Project Name **Q-Kids Childcare Project**
 Project Number **00507**
 Date Issued **July 28, 2022**

To **To All Bidders and Plan Holders**

ELECTRICAL ADDENDUM #02

Date: July 27, 2022
Project: Q-Kids Daycare Centre
Project №: 2108

PROPOSED BC HYDRO OVERHEAD MAST LAYOUT
SCALE: 1/4"=1'-0"

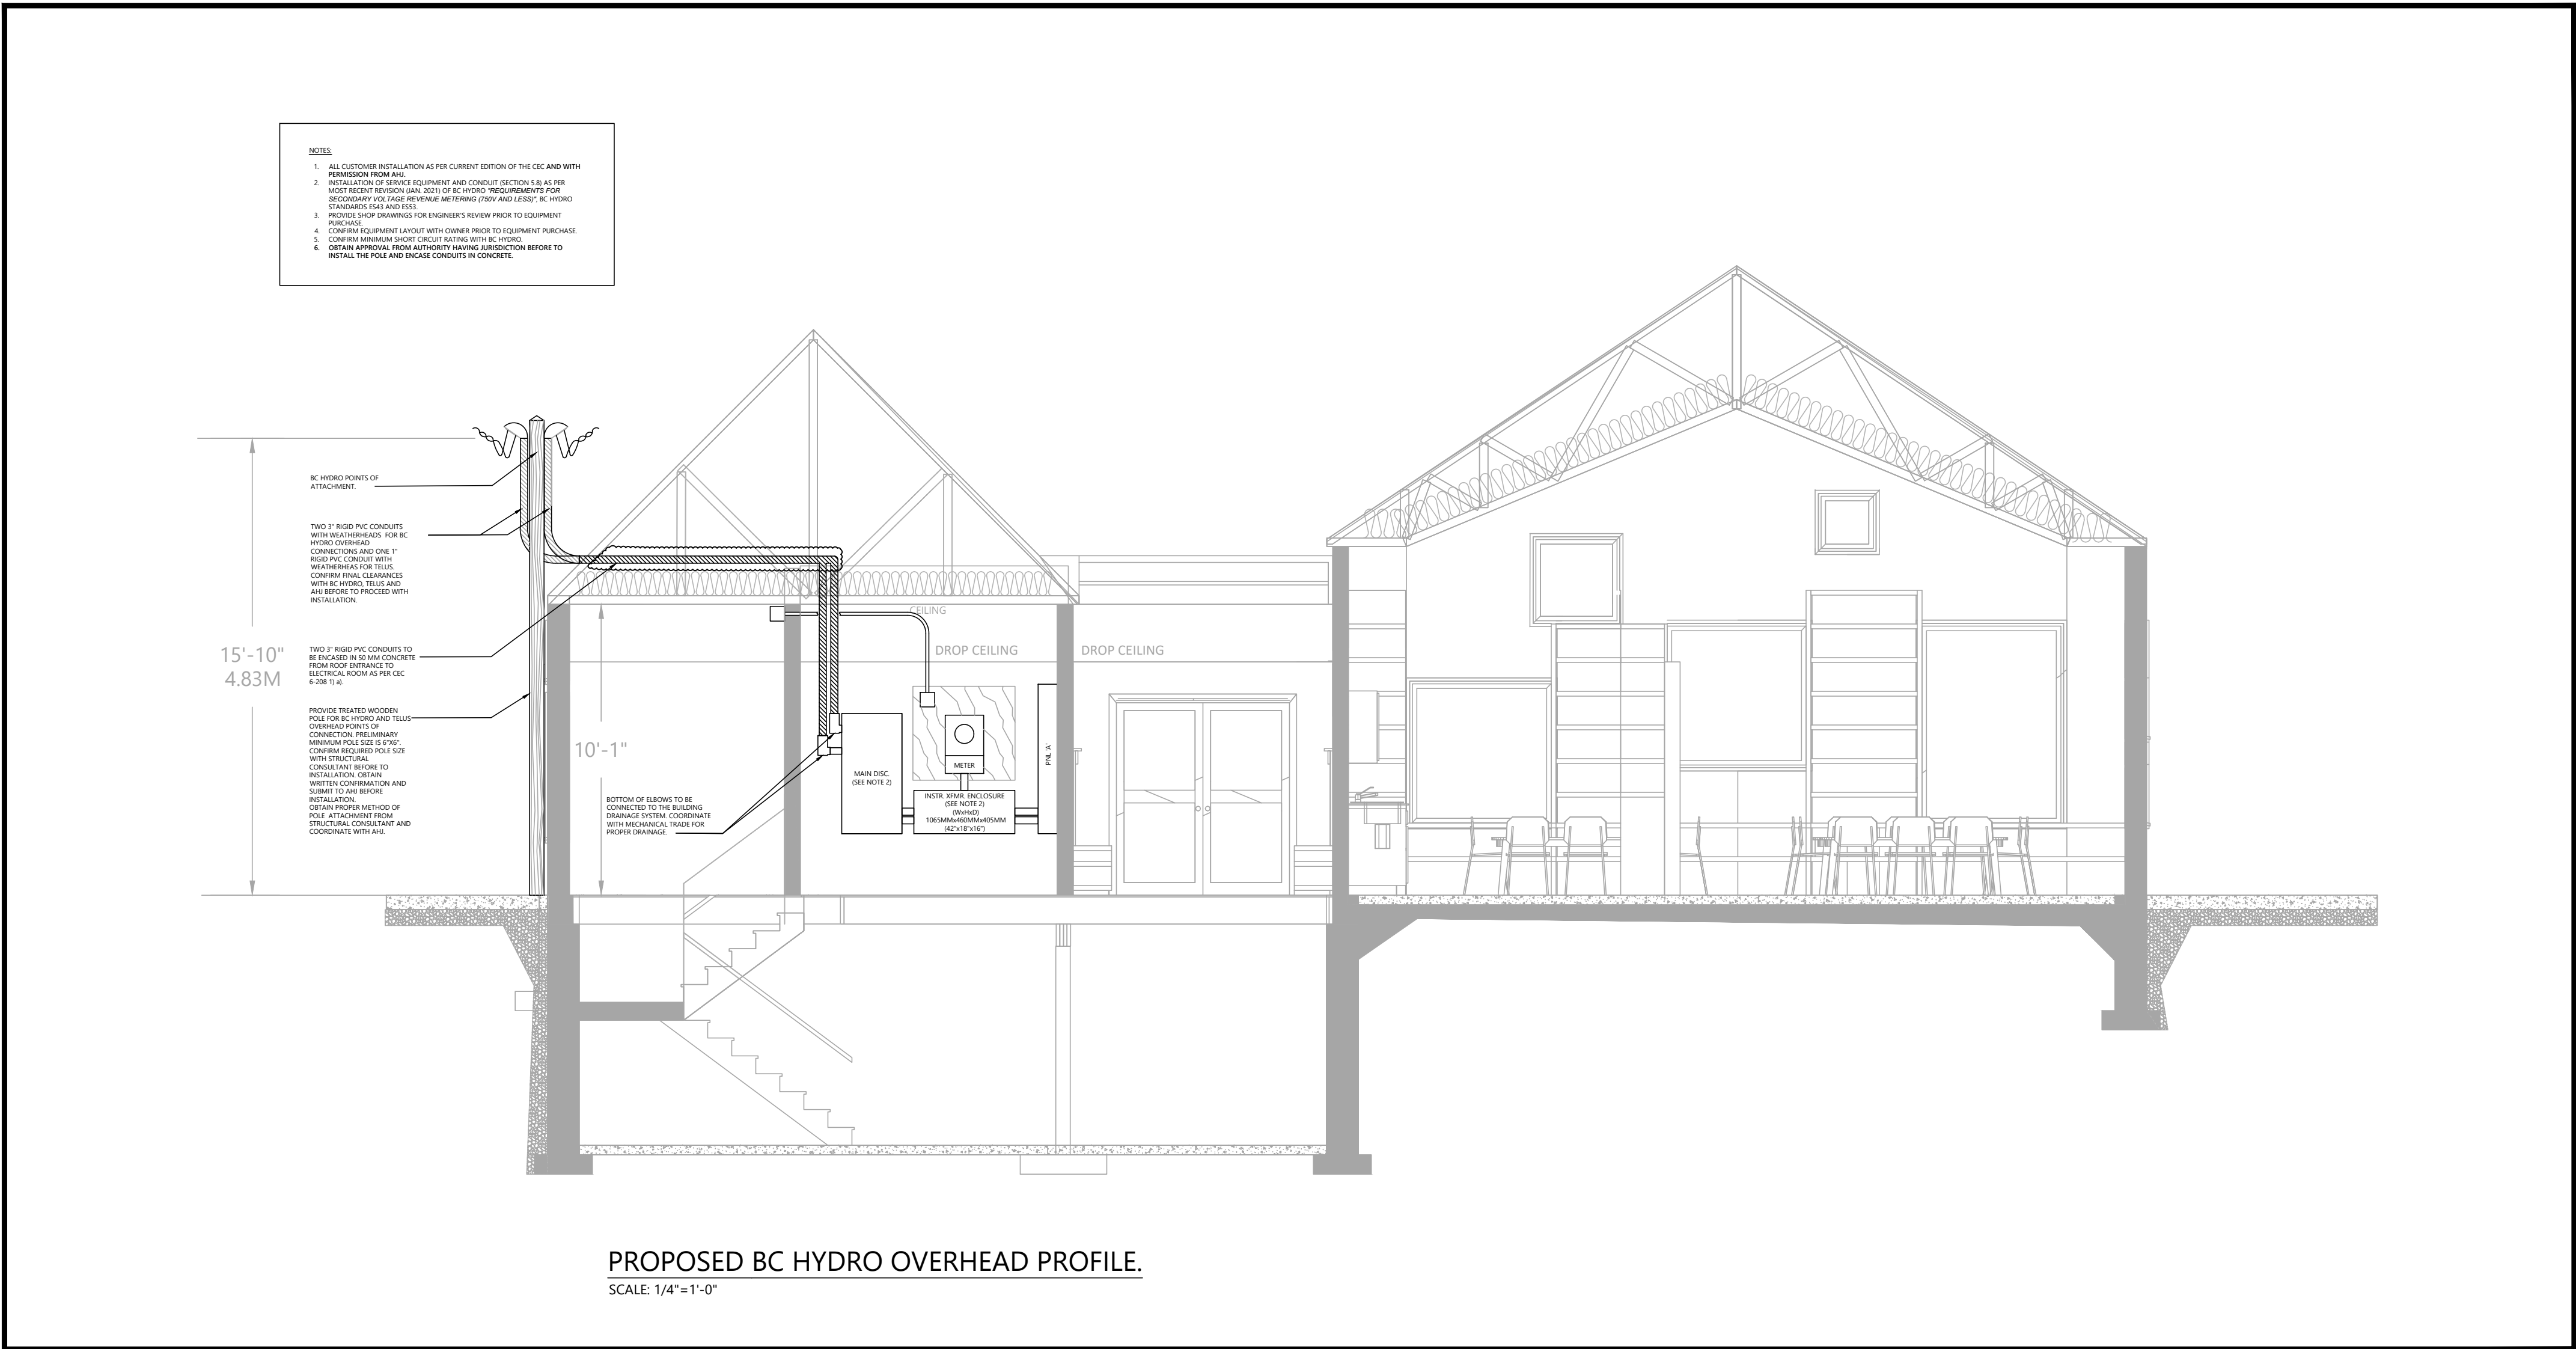
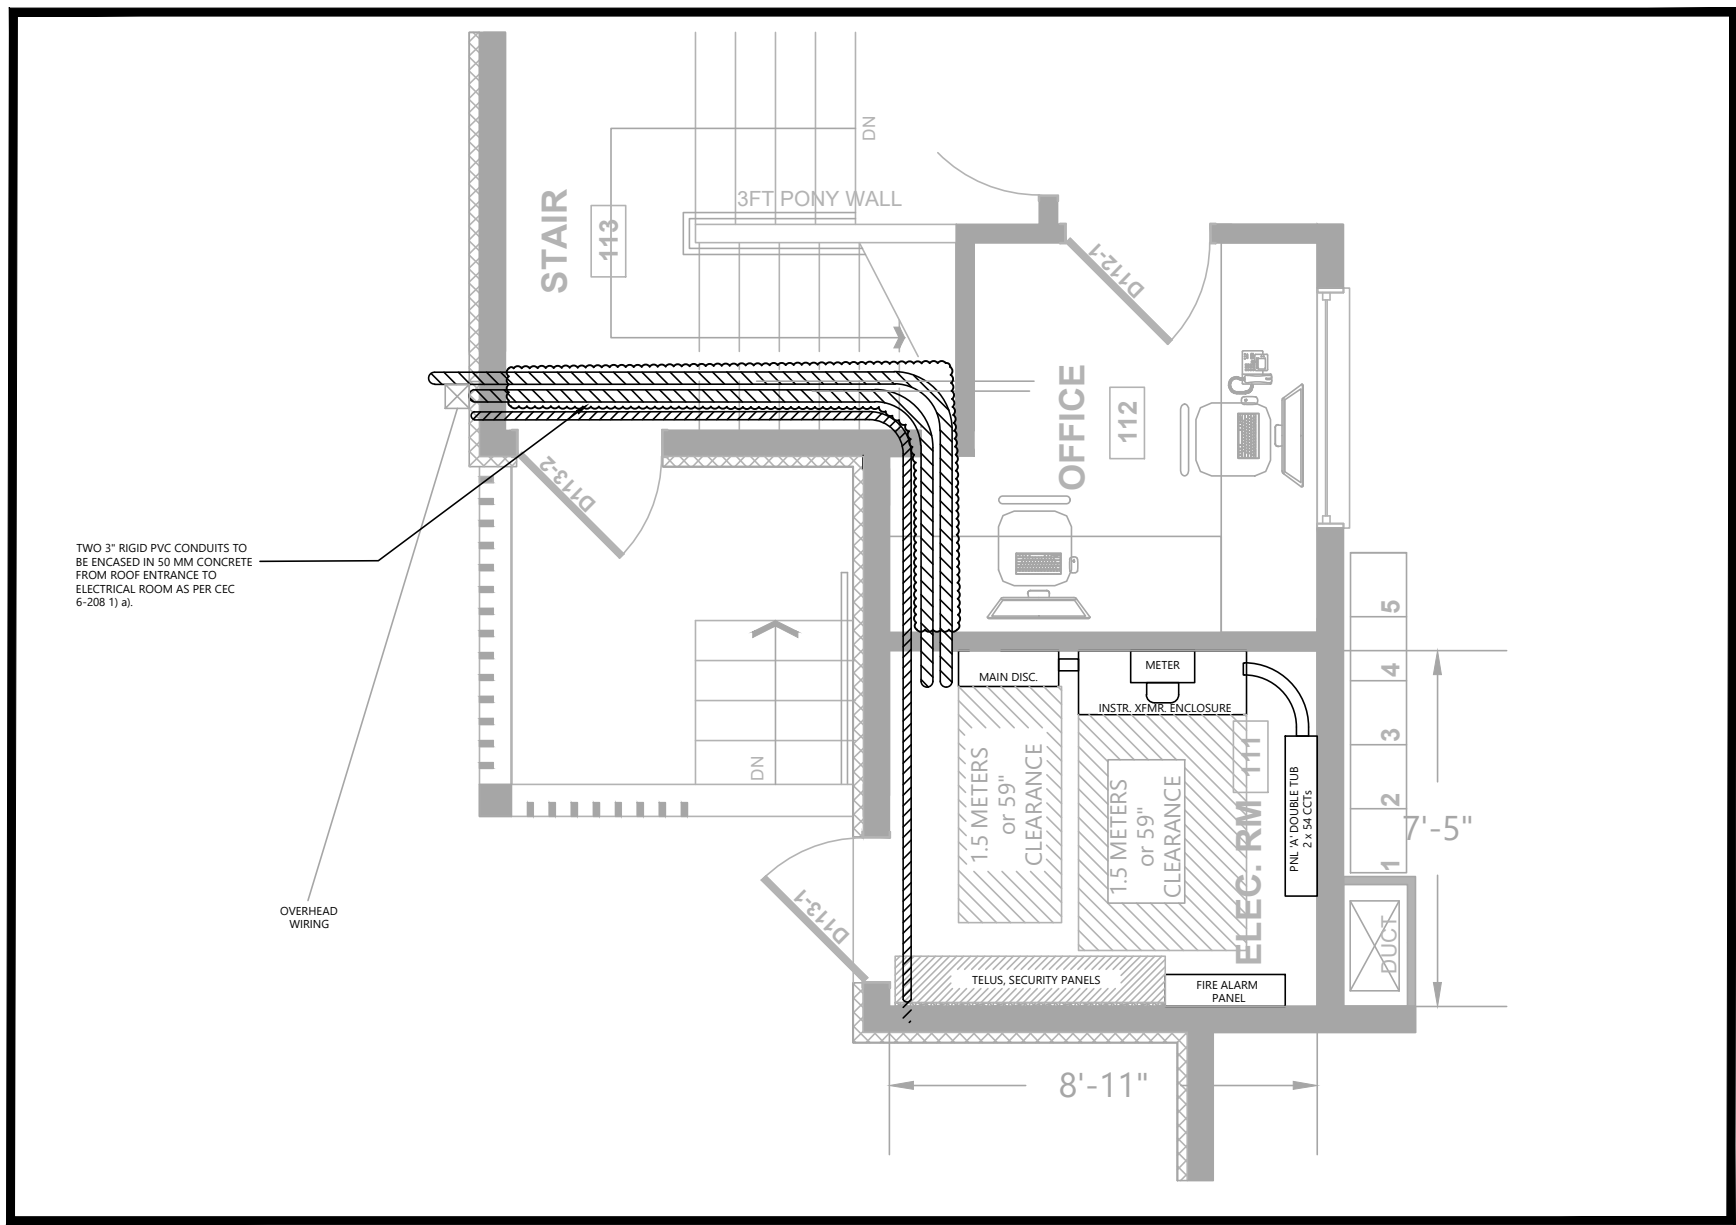
1. Q: Current electrical code prohibits the length and location of the overhead service conductors, unless encased in min.50mm concrete on all sides. Is that the intention of the engineer?
A: Please refer to attached updated Drawing E0.3. Concrete encasement is required from the roof penetration to the electrical room as per CEC 6-208 1) a). Rigid PVC conduits shall be used as service raceways.
